**STATE SIGNIFICANT DEVELOPMENT APPLICATION – 8669
ST ALOYSIUS' COLLEGE – CONCEPT APPROVAL AND STAGE 1 BUILT FORM APPROVAL**

St Aloysius' College – SSDA 8669

Independent Planning Commission

1 Plan - LV 6 PROPOSED
Scale: 1:200

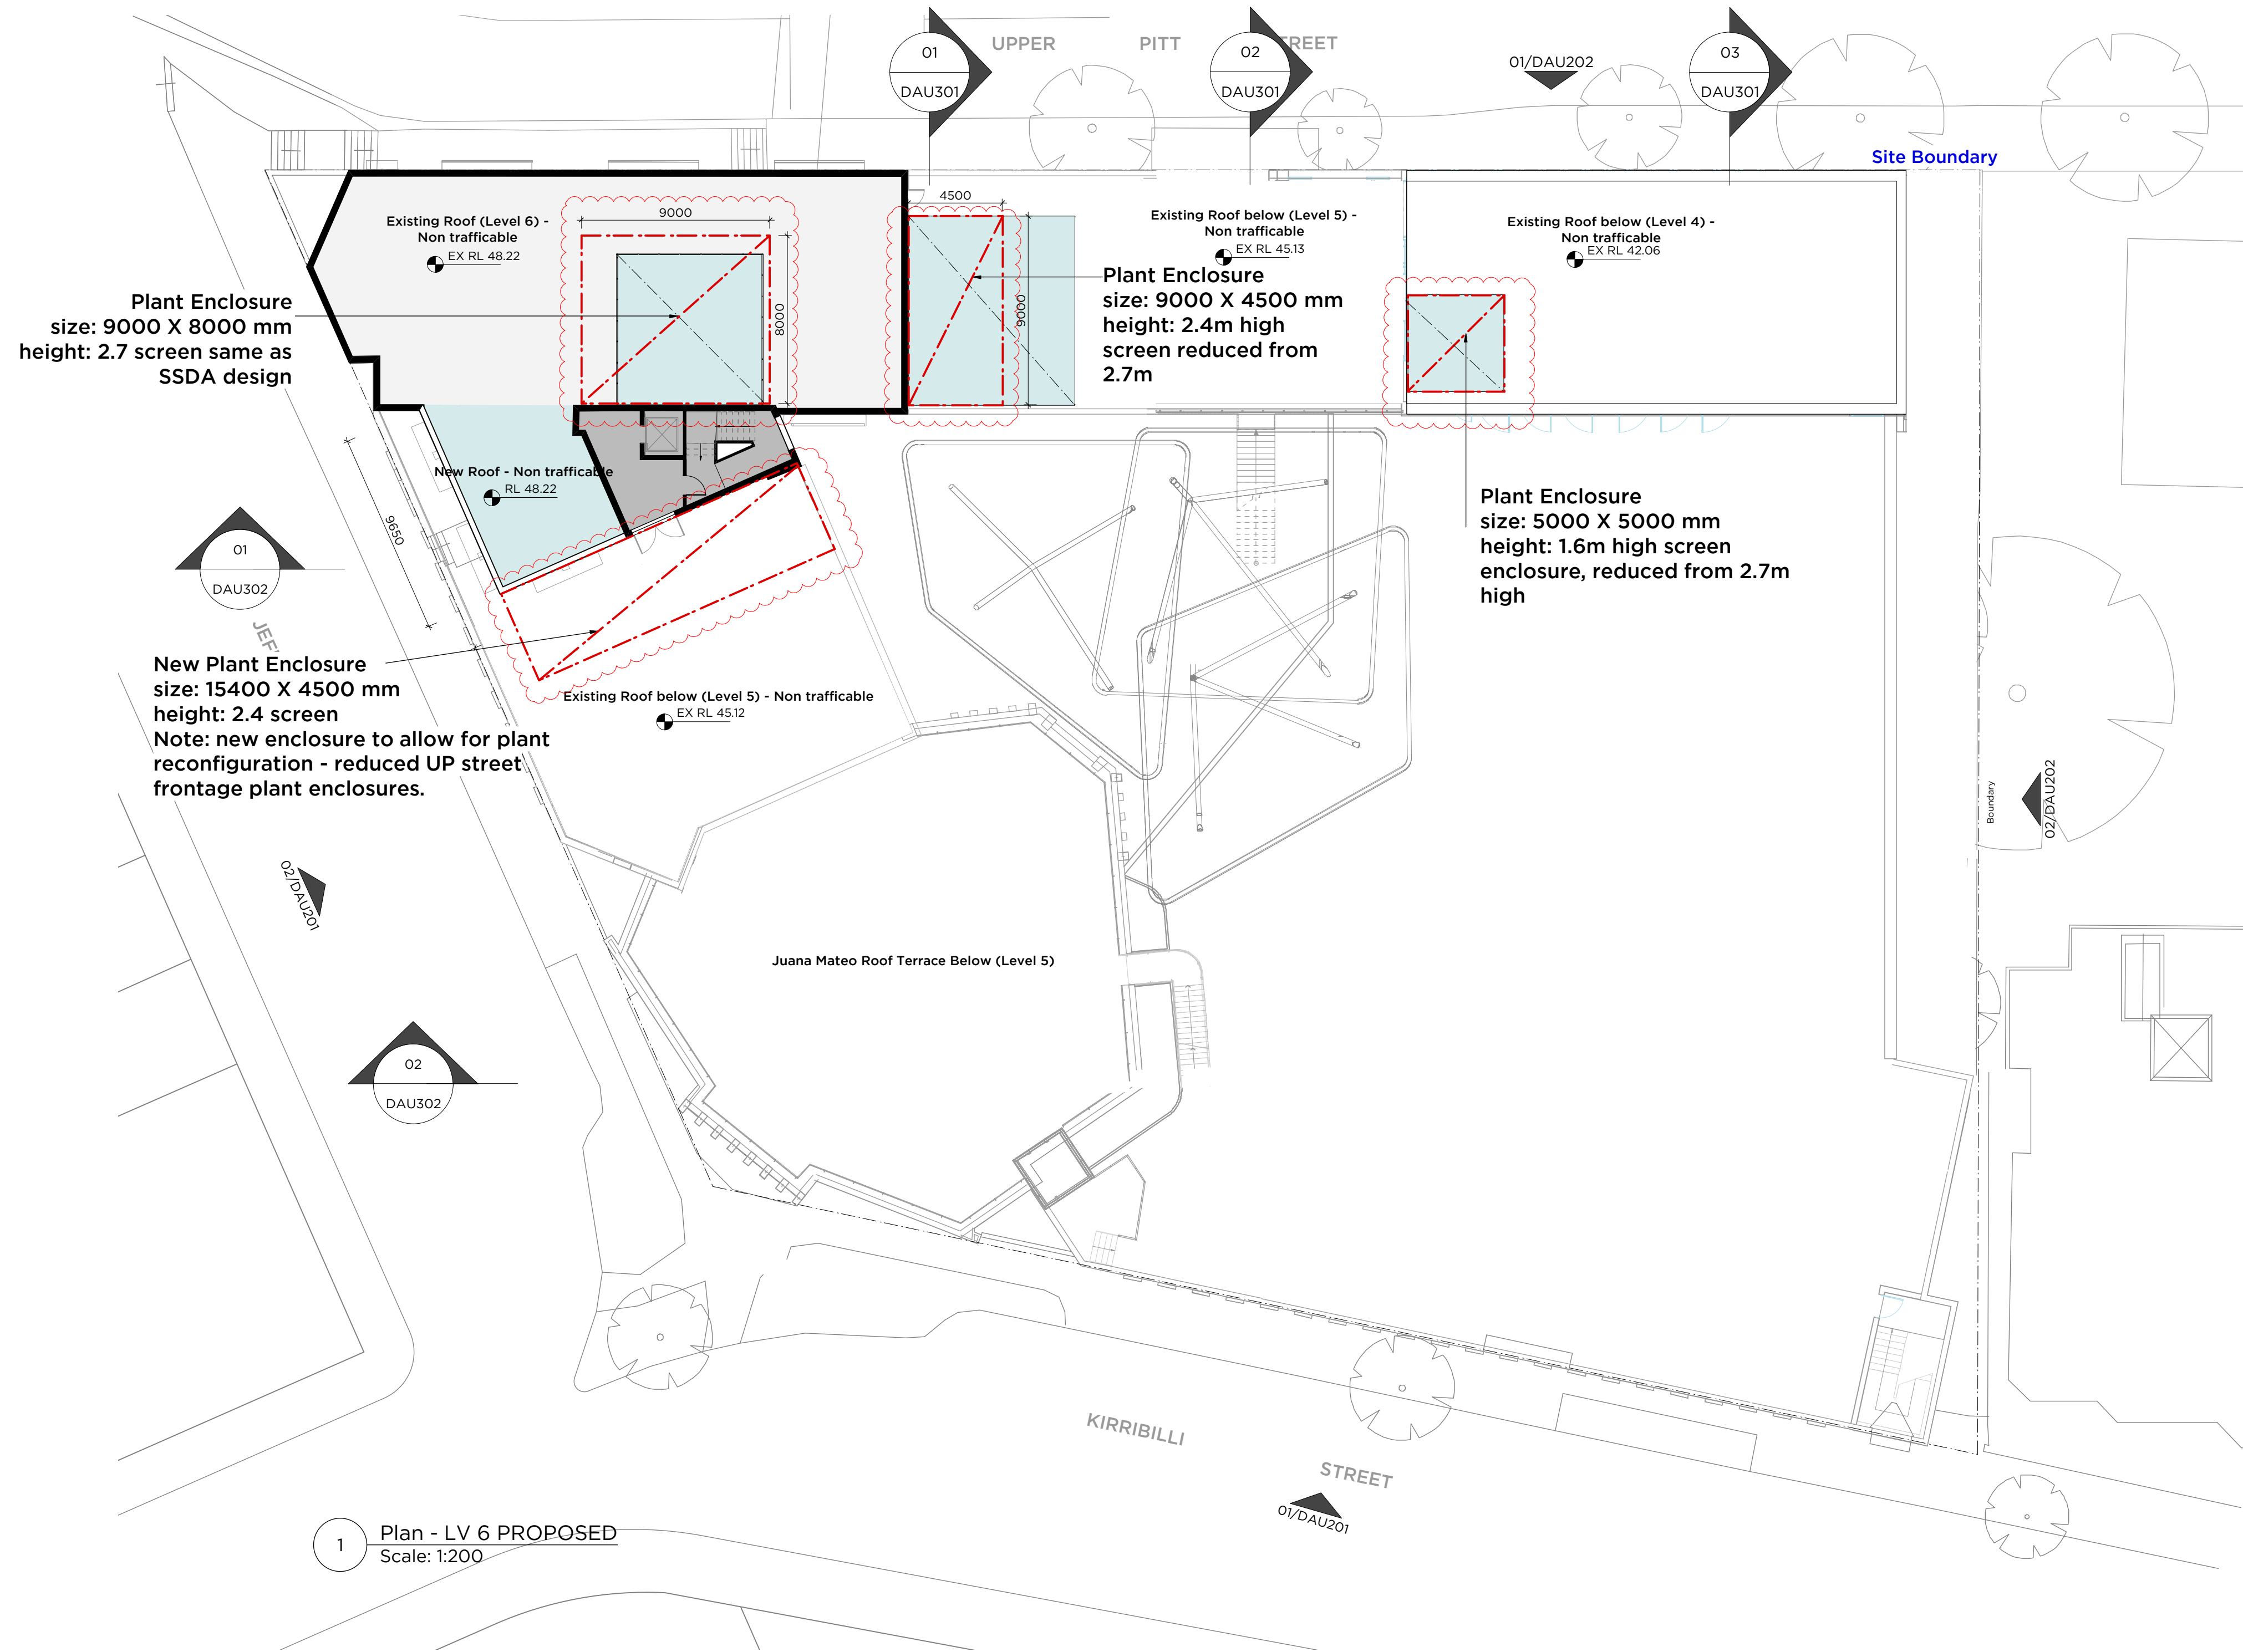
<ul style="list-style-type: none"> Justification for the location of the plant and whether there is any opportunity for relocation or reduction in size. 	<p>Refer to Appendix B, Drawing No. DAU130 and DAU202.</p> <p>The plant room has been amended to improve the views from Upper Pitt Street. Consequently, a new plant enclosure on the Level 5 Roof Level is being sought to accommodate the reduction in plant room on the Upper Pitt Street frontage.</p>
<ul style="list-style-type: none"> Does the plant shown in the southeast building on Levels 1 and 2 service this building as well as the infill building. 	<p>The Plant Room shown on the south-east building on Levels 1 and 2 services the eastern wing and has been adequately addressed in the addendum Noise Impact Assessment prepared by SLR, V3.0, dated April 2019. Figure 10 and extracted below of the addendum Noise Impact Assessment illustrates the location of the mechanical plant for the Main Campus.</p>

Potential Roof Top Plant Enclosure Modification.
